Re: 07_0018-Mod 11 Rasp Mine Modification11 - Submissions Report

Appendix A – EMM Consulting review of Rasp Mine Water Take and Groundwater impact assessment

Re: DPE Water - Mod 11 Request for Additional Information

Rasp Mine Modification 11
Groundwater-related DPE Water Response
Figure 2.1

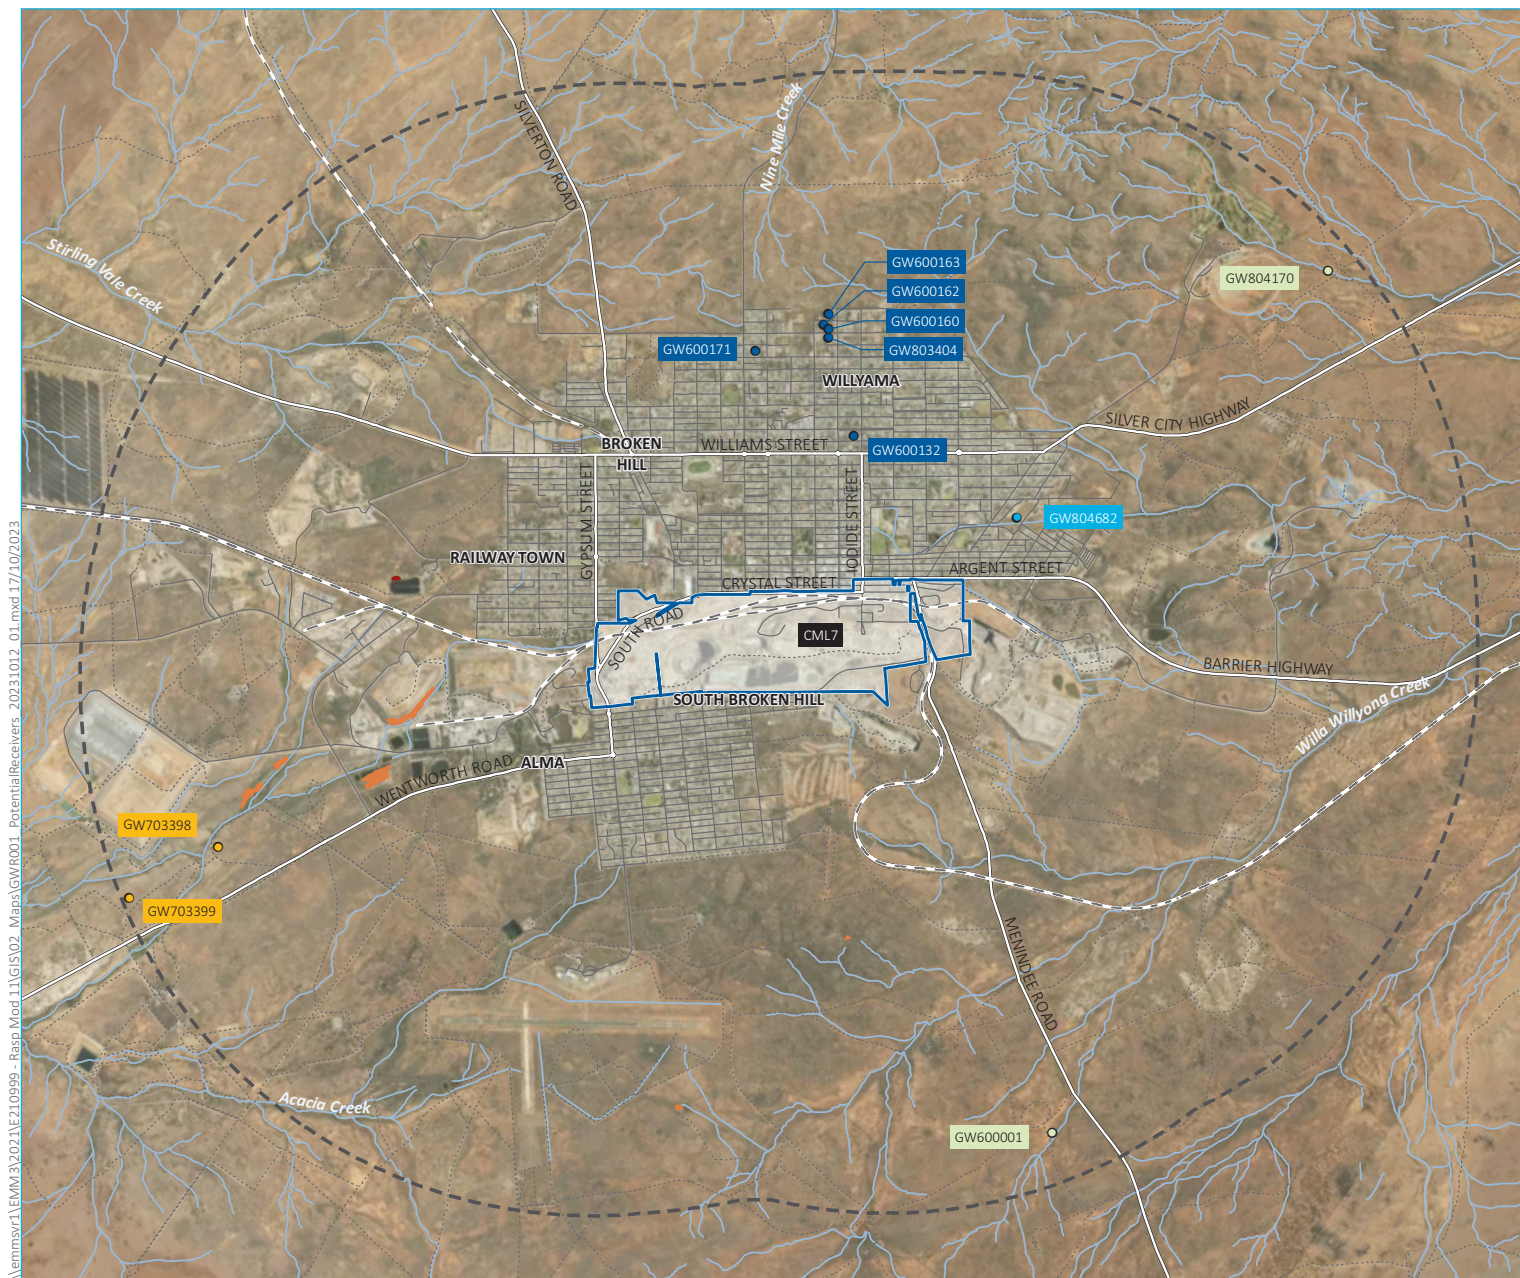
Issue 2 Ground Water Impact Assessment: The proponent should provide a statement of impact against the minimal impact considerations of the NSW Aquifer Interference Policy (2012).

Further assessment indicates the mapped high priority GDEs align with the terrestrial GDEs categorised as high–very high priority within the publicly available High Ecological Values Aquatic Ecosystems (HEVAE) GDE dataset (refer to Figure 2.1).

Registered bores in the vicinity of the mining lease that have the potential to be water supply bores are shown on Figure 2.1. Further details of all the registered bores are provided in the bore summary table in Appendix B.
